Project	IEEE 802.16 Broadband Wireless Access Working Group < http://ieee802.org/16 >	
Title	[Terminal Assisted QoS support]	
Date	[2004-03-12]	
Submitted		
Source(s)	Park, Yunsang Joo, Panyuh Koo, Changhoi Samsung Electronics 416, Maetan-3dong, Youngtong-gu Suwon-si, Gyeonggi-do, Korea	Voice: [82-31-279-5370] Fax: [82-31-279-5515] yunsang.park@samsung.com chkoo@samsung.com panyuh@samsung.com
Re:	IEEE 802.16d Terminal assisted QoS support	
Abstract	This contribution contains a proposal that helps to support QoS requirement of services by providing each mobile terminal's unique status, such as channel status and internal memory usage status, to the corresponding network.	
Purpose	Propose to IEEE 802.16 d or e ad-hoc group	
Notice	This document has been prepared to assist IEEE 802.16. It is offered as a basis for discussion and is not binding on the contributing individual(s) or organization(s). The material in this document is subject to change in form and content after further study. The contributor(s) reserve(s) the right to add, amend or withdraw material contained herein.

Terminal assisted QoS

Figure 23—Bandwidth request header format

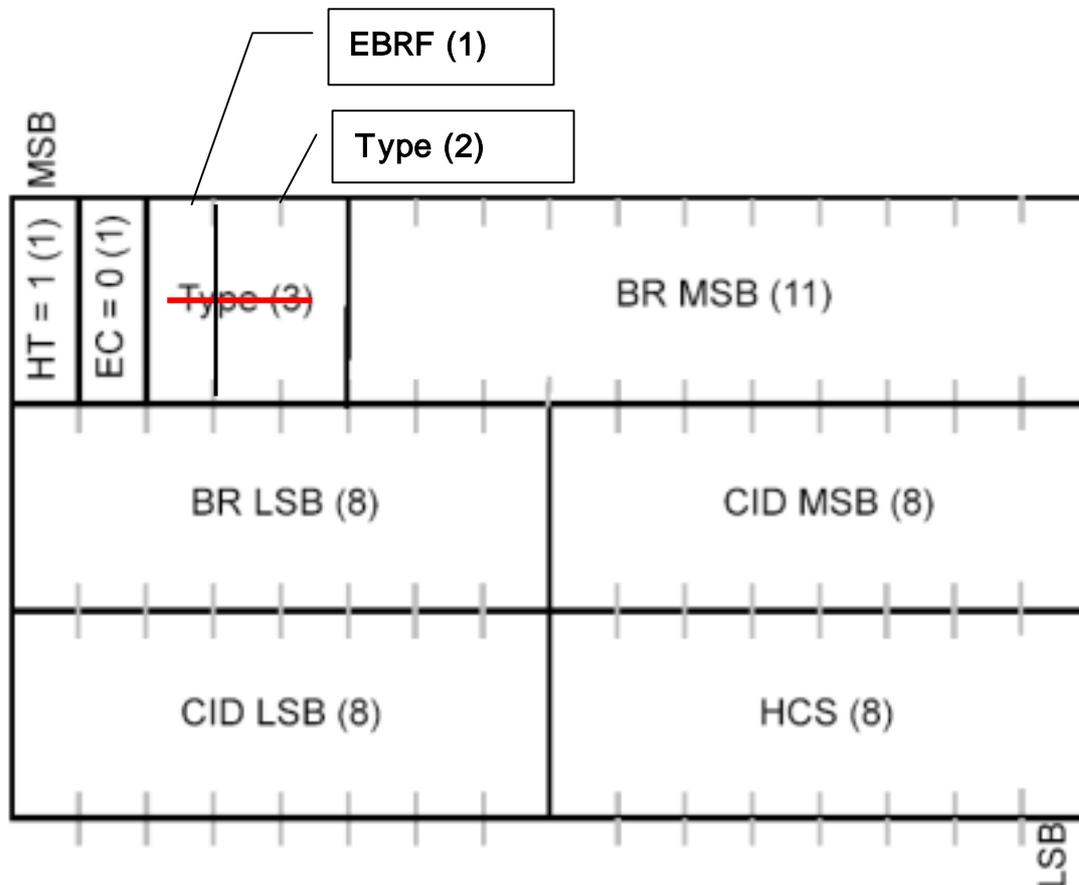
[Modify the Figure 23 in page 56, IEEE802.16-REVd/D3-2004]

[Modify the sentences, line 35 – 36 page 56, IEEE802.16-REVd/D3-2004]

The Bandwidth Request shall have the following properties:

- a) The length of the header shall always be 6 bytes.
- b) The EC field shall be set to 0, indicating no encryption.
- c) The CID shall indicate the connection for which uplink bandwidth is requested.
- d) The bandwidth Request (BR) field shall indicate the number of bytes requested.
- e) The allowed types bandwidth requests are “00” ~~“000”~~ for incremental and “01” ~~“004”~~ for aggregate
- f) The Extra Bandwidth Request Flag (EBRF) is “0” for not requested and “1” for requested
